Cicala Rev B FIT STUDY system block diagram

Cicala		
Sheet: /		
File: cicala_rev_b.kicad_sch		
Title: Cicala Rev B FIT STUDY schematic overview		
Size: A4	Date: 2026-09-07	Rev: Rev B FIT – NOT FOR FA
KiCad E.D.A. 10.0.5		Id: 1/5

Title: Waveshare_352_V11_UC8253 e-paper interface and boost

Panel FPC

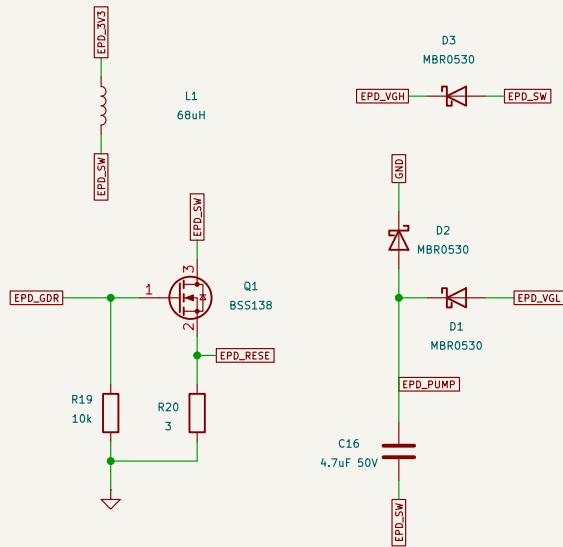
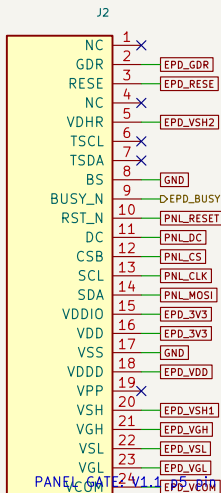
PANEL pin table conflicts with p16 circuit (pins 1/4/5). Boost values unqualified.

V1.1 pin table: pins 1/4 NC, pin 5 VDHR. HAT boost: 68uH / BSS138 / 3R.
